PLANNING COMMISSION MEETING AGENDA

MAY 2, 2023

1. LSDP: Cheltenham Townhomes

3. LSDP: Jiffy Trip

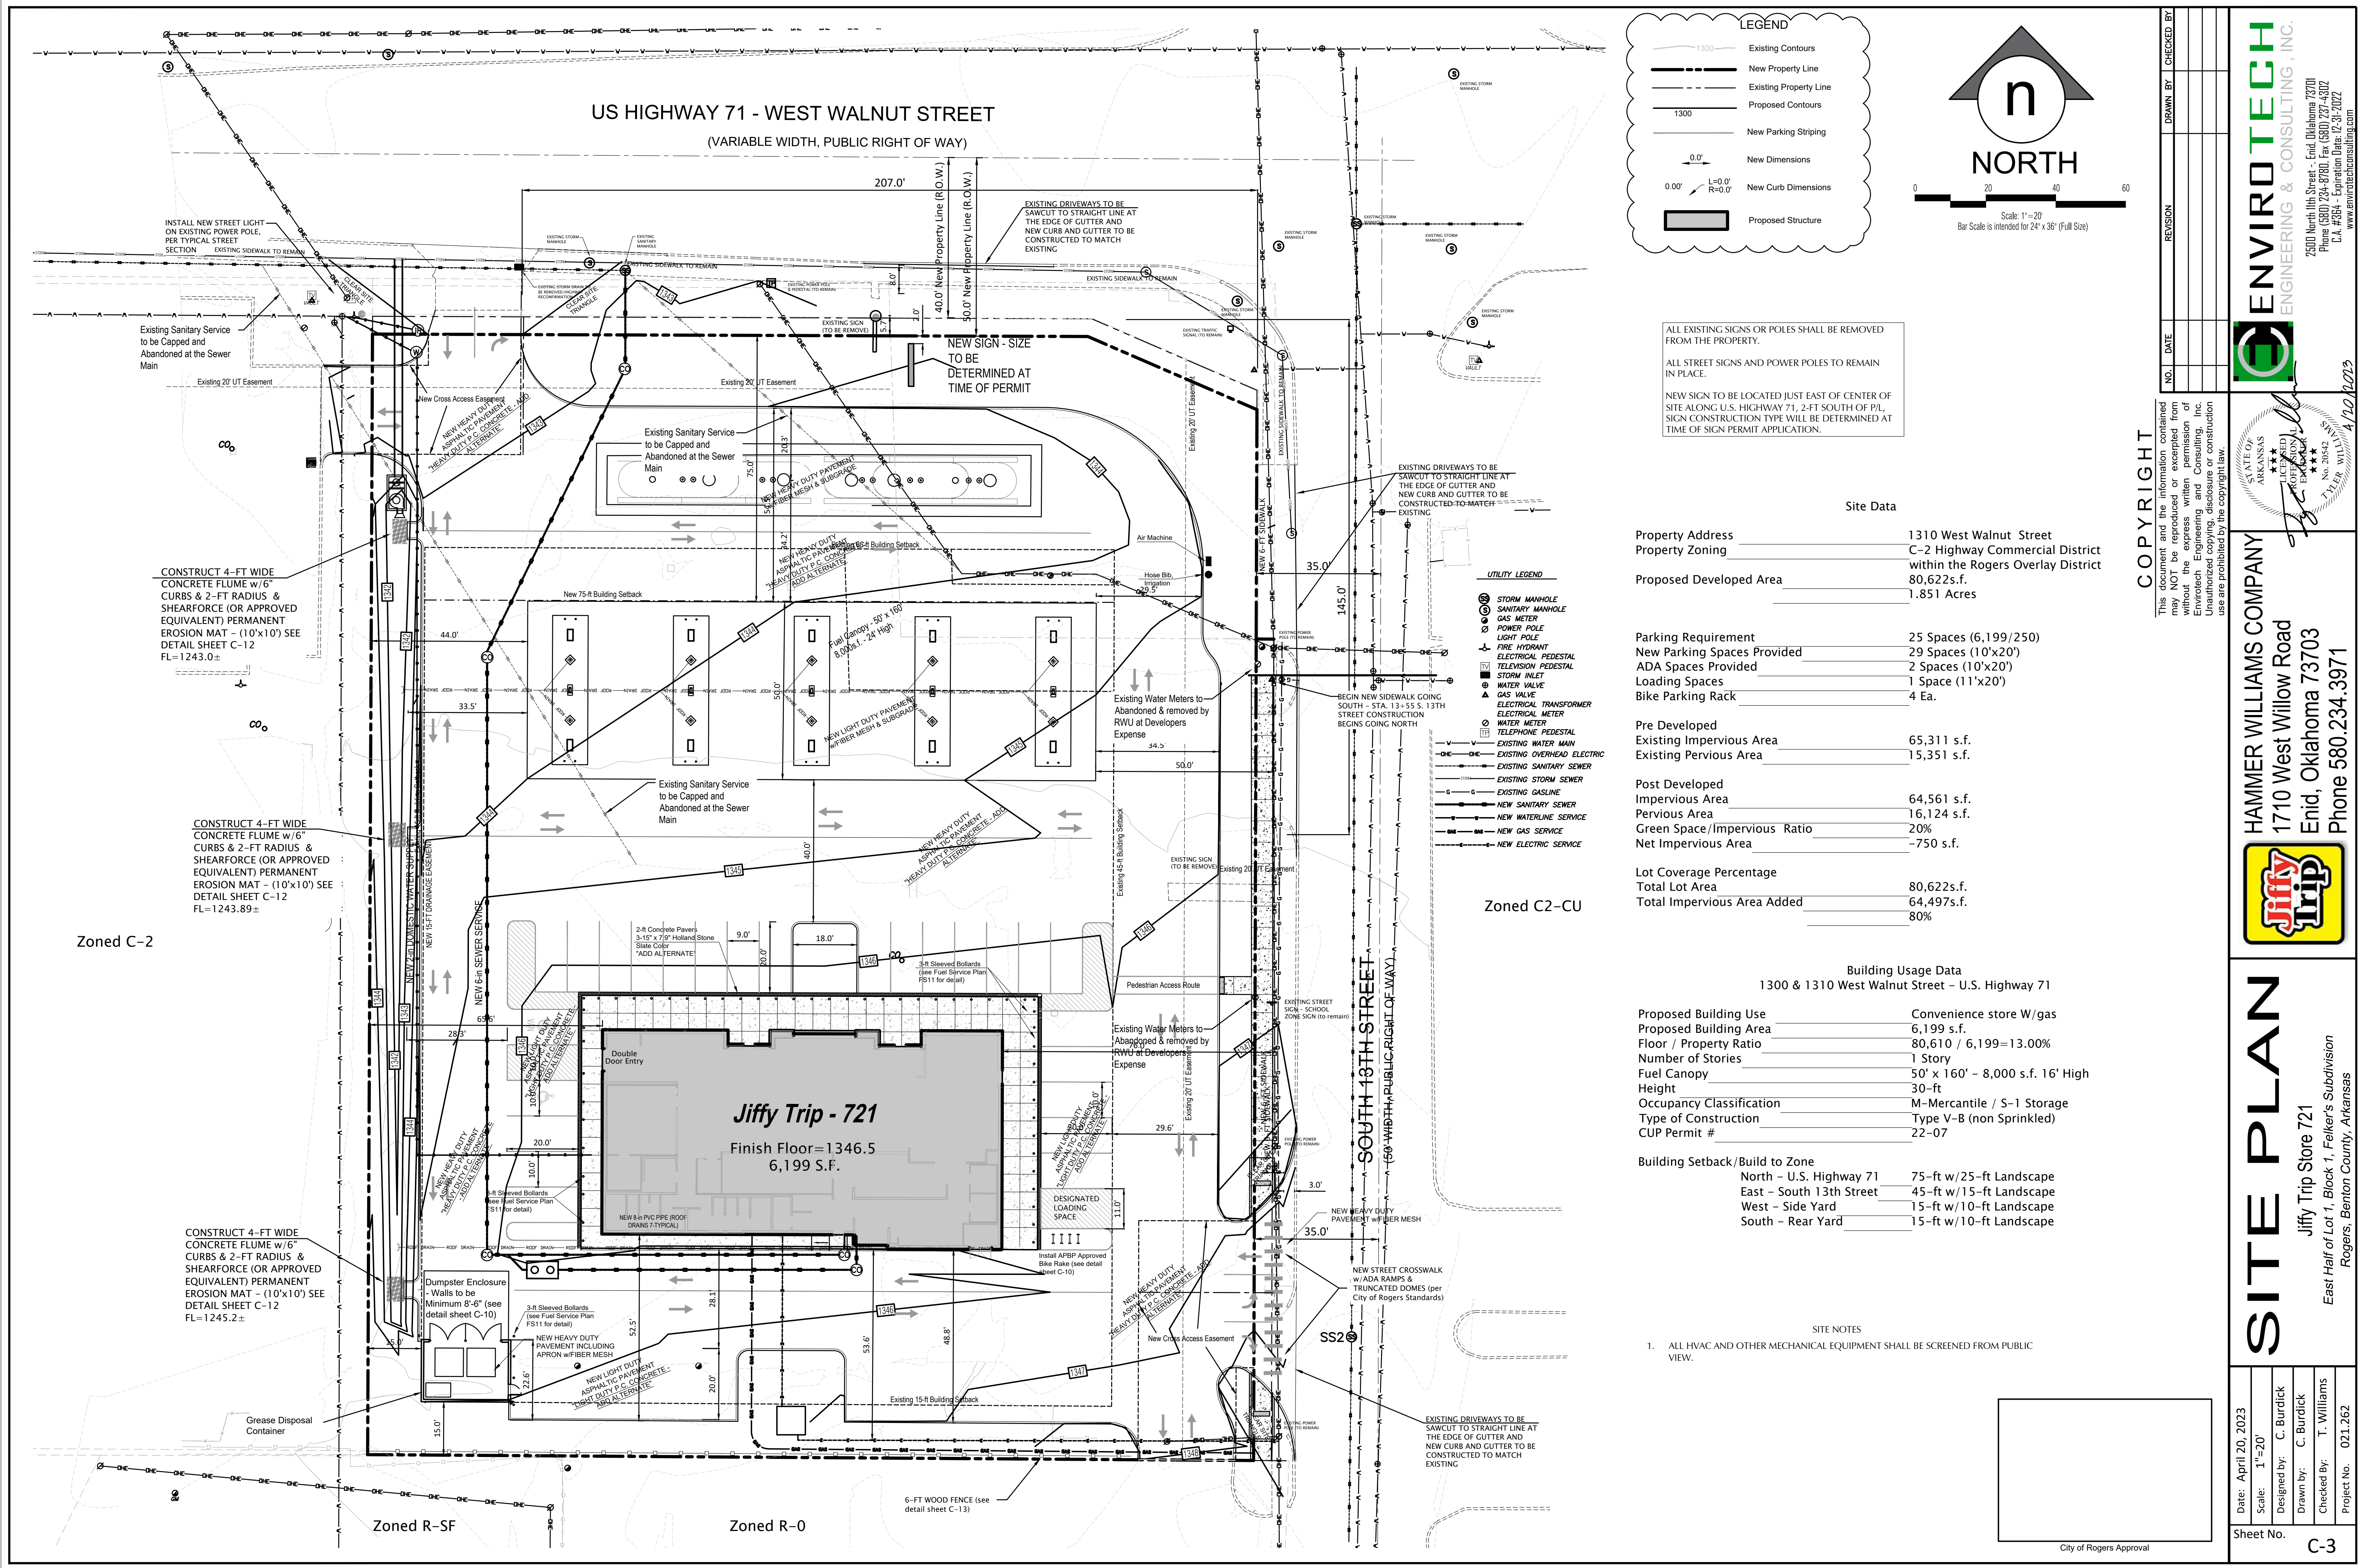
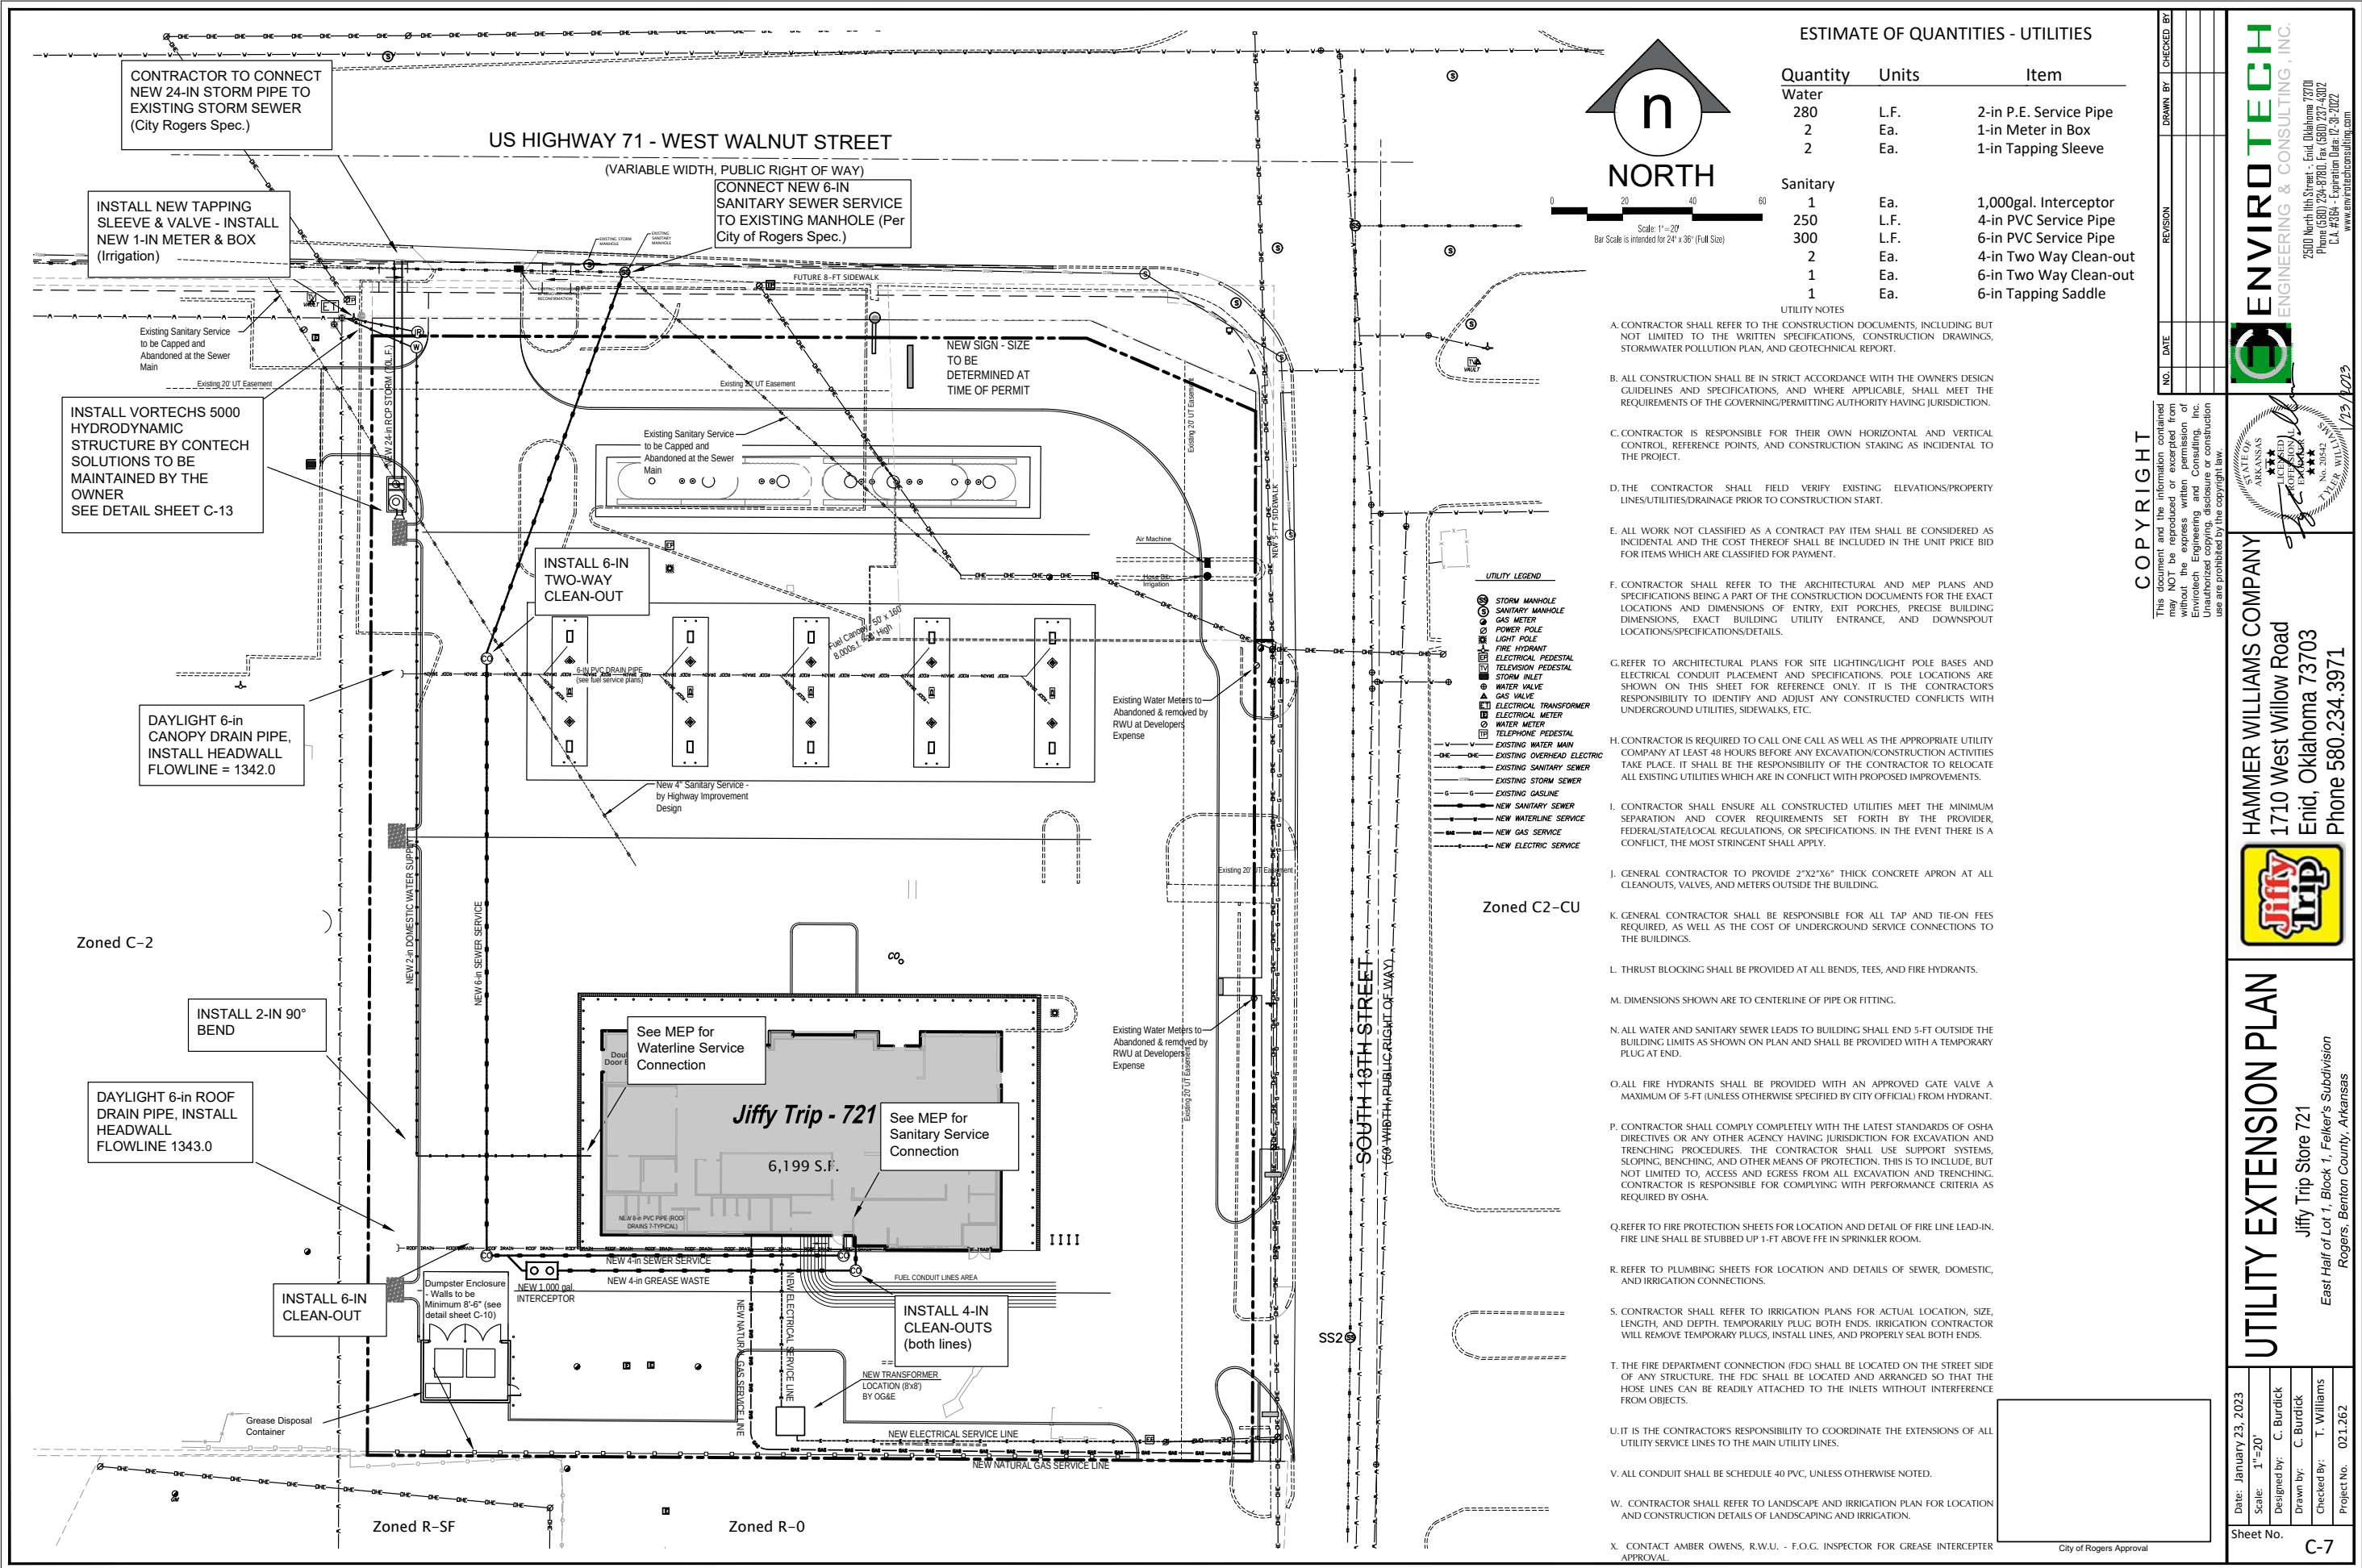
4. Correct the note on Sheet C-7, "CONNECT NEW 6-IN SANITARY SEWER SERVICE TO EXISTING MANHOLE (Per City of Rogers Spec.)" to state (Per Rogers Water Utilities Spec.)

6. On sheet C-7, what is the note "New 4" Sanitary Service – by Highway Improvement Design" for. There is no Highway Improvement Design, and it is pointing to a sewer service line that is called to be removed on the Demolition Plan Sheet.

7. On sheet C-7, the text box for the water meter notes the water meter is for Irrigation, but is connected to the building. Should this be 2 water meters (one domestic and one irrigation)? Or is the note for Irrigation in error?

8. On sheet C-7, that are text boxes that are not pointing at the items being referenced. See text box with "INSTALL 6-IN CLEAN-OUT" at the southwest corner of the plans for an example.
